Body and Equipment Guideline (BEG)

Addendum

Sprinter 2019 – Model Designation 907

Addendum Topic: Sensors

Figure 1 Field of vision

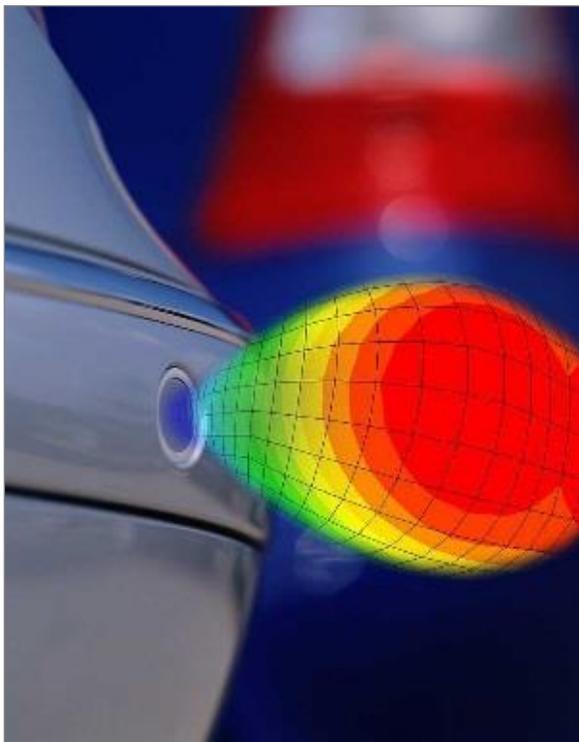
The Parktronic is an electronic parking aid with ultrasound and uses six distance sensors in the front bumper and six distance sensors in the rear bumper to monitor the vehicle's surroundings. The Parktronic provides a visual and acoustic indication of the distance between the vehicle and an obstacle.

The following pictures show the field of vision and the signal funnel of one parktronic sensor.

To ensure that the functioning of the system is not affected, on no account should the following changes be made:

- Changing the position of the sensor
- Attachment of detachable parts that can shadow the area of or around the sensor
- No additional painting and no foils (also refer to the warning)

If necessary, the system must be deactivated.

- Range of ultrasonic is about 1.2 m (47.2 in)
